WELL NAME: YANKOVICK #1, API #: 043-40037, INSP. # 695108710

COLORADO
Energy & Carbon Management
Commission
Department of Natural Resources

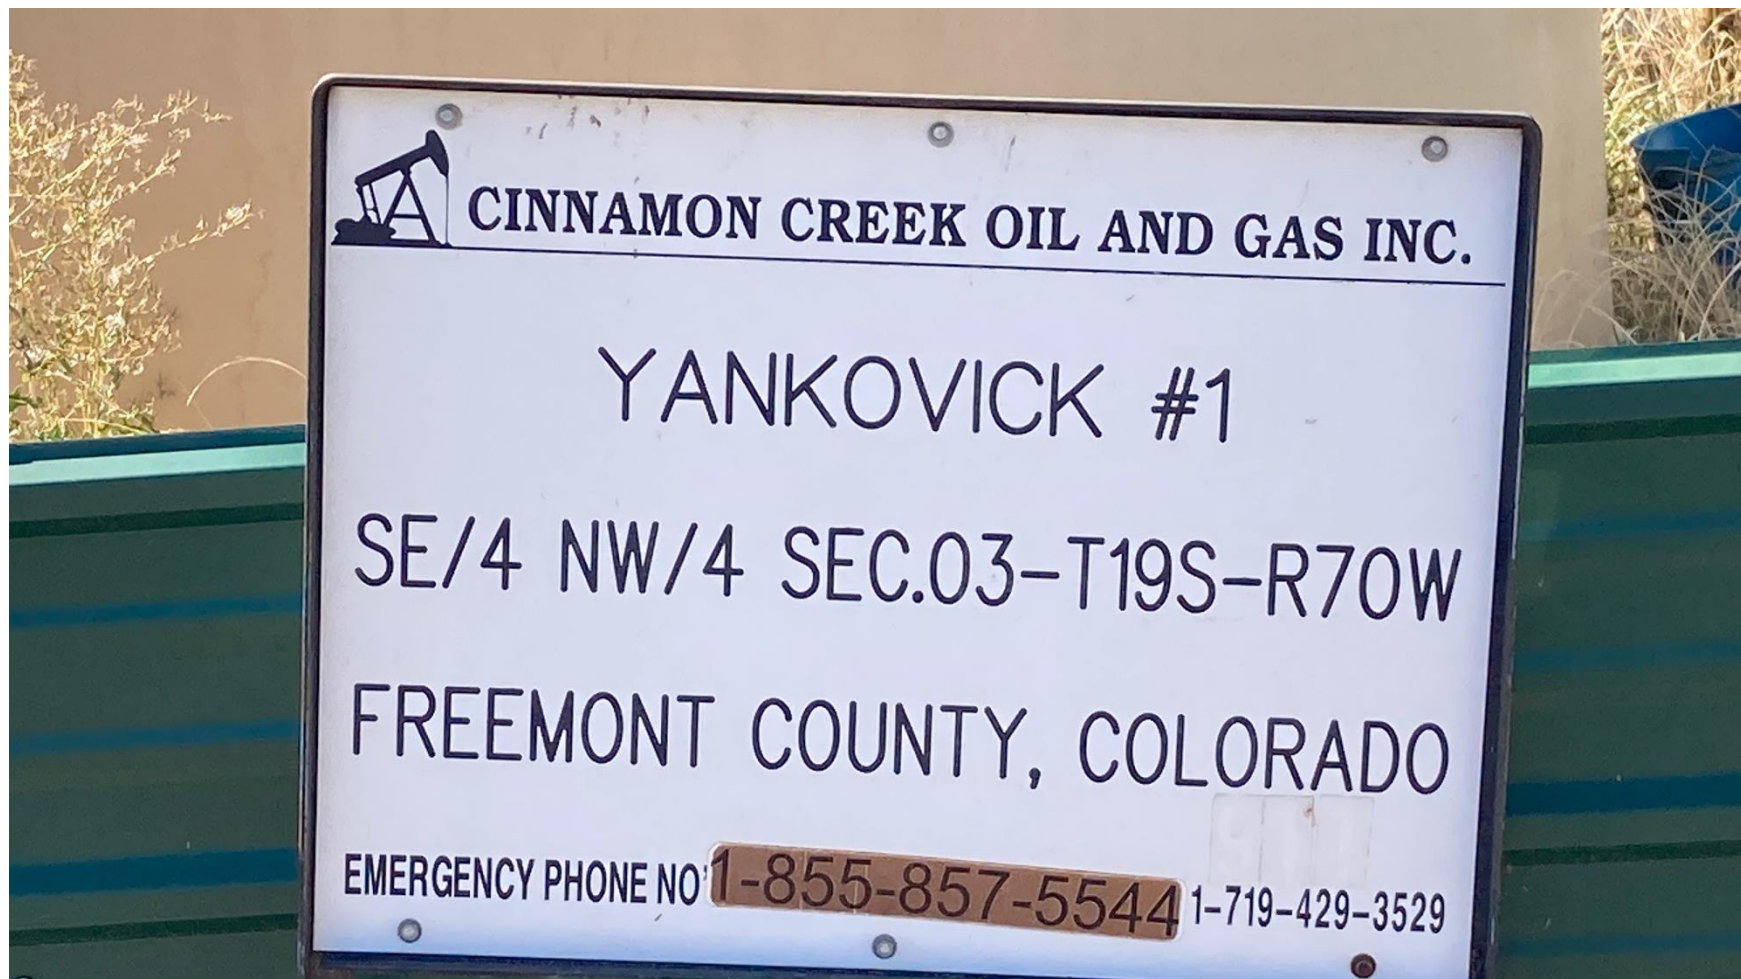
PHOTO 4: TANK BATTERY/ NO TANK BAPACITY POST ON OR AT TANK BATTERY. POST CAPACITY PER RULE 605. CA DATE 11-19-2023.

PHOTO 5: WEEDS INSIDE TANK BATTERY BERM. MAINTAIN WEEDS PER RULE 606. CA DATE 11-19-2023.

PHOTO 6: WEEDS AROUND WELLHEAD/PUMPJACK. MAINTAIN WEEDS PER RULE 606. CA DATE 11-19-2023.

PHOTO 7: AREA OF IMPACTED SOIL UNDER PUMPJACK GEAR BOX. Conduct maintenance on equipment, cleanup stained material and review self inspection processes. COMPLY WITH RULE 1002,(2).D CA DATE 11-19-2023.

PHOTO 8: THERE ARE EXPOSED WIRE CONNECTIONS INSIDE WOOD ELECTRIC PANEL BOX. Securely fasten all valves, pipes, fittings, electric equipment and Production Facilities to ensure good mechanical condition, inspect at regular intervals and maintain in good mechanical condition per Rule 603.O(6) CA DATE 11-19-2023.

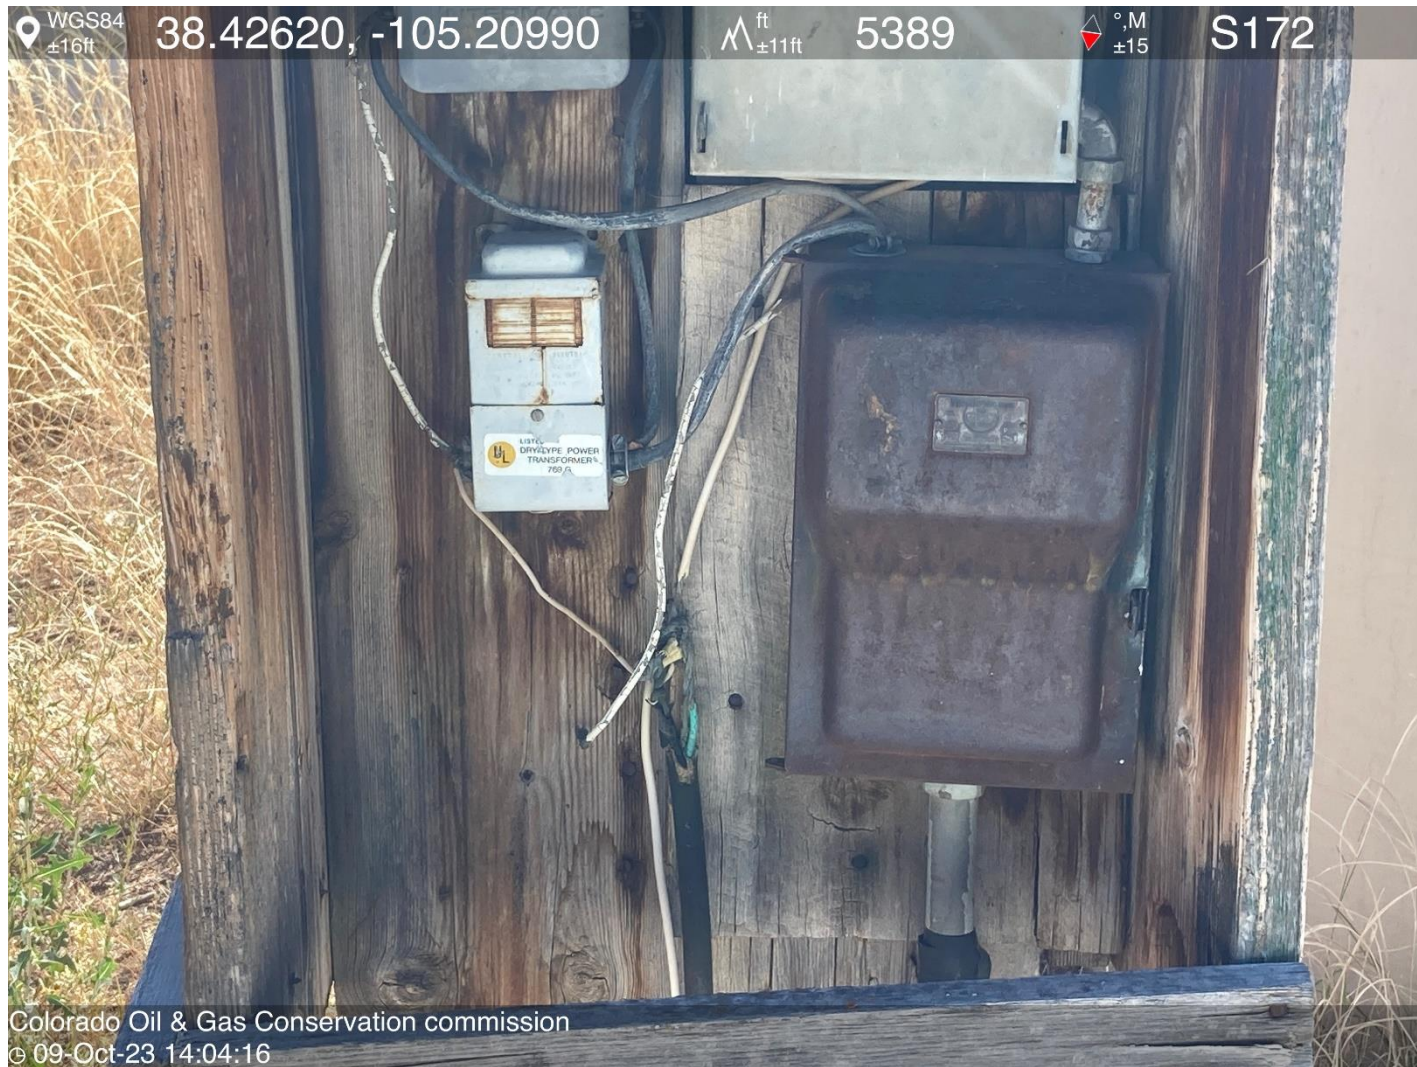
PHOTO 9: THERE ARE EXPOSED WIRE CONNECTIONS INSIDE WOOD ELECTRIC PANEL BOX. Securely fasten all valves, pipes, fittings, electric equipment and Production Facilities to ensure good mechanical condition, inspect at regular intervals and maintain in good mechanical condition per Rule 608.e. CA DATE 11-19-2023.

PHOTO 10: ELECTRIC PANEL IS APP. 3' FROM CRUDE OIL TANK BATTERY.

PHOTO 11: THERE APPEARS TO BE A RUBBER FLAP COVER ON TANK BATTERY WITH NO SAFETY VALVE INSTALLED ON TANK. Tanks will function as sealed and ventless with gas released only through a vapor control system or properly sized pressure relief valve. per Rule 608.a.(9). CA DATE 10-21-2023.

**PHOTO 12: BRADENHEAD IS NOT ACCESSABLE. Install appropriate fittings to allow bradenhead visual inspection as per Rule 419.a.(1), (2).
CA DATE 11-19-2023.**

PHOTO 13: TRASH INSIDE TANK BATTERY CONTAINMENT (BLUE 5 GAL. BUCKET. REMOVE TRASH PER RULE 606. CA DATE 11-19-2023.
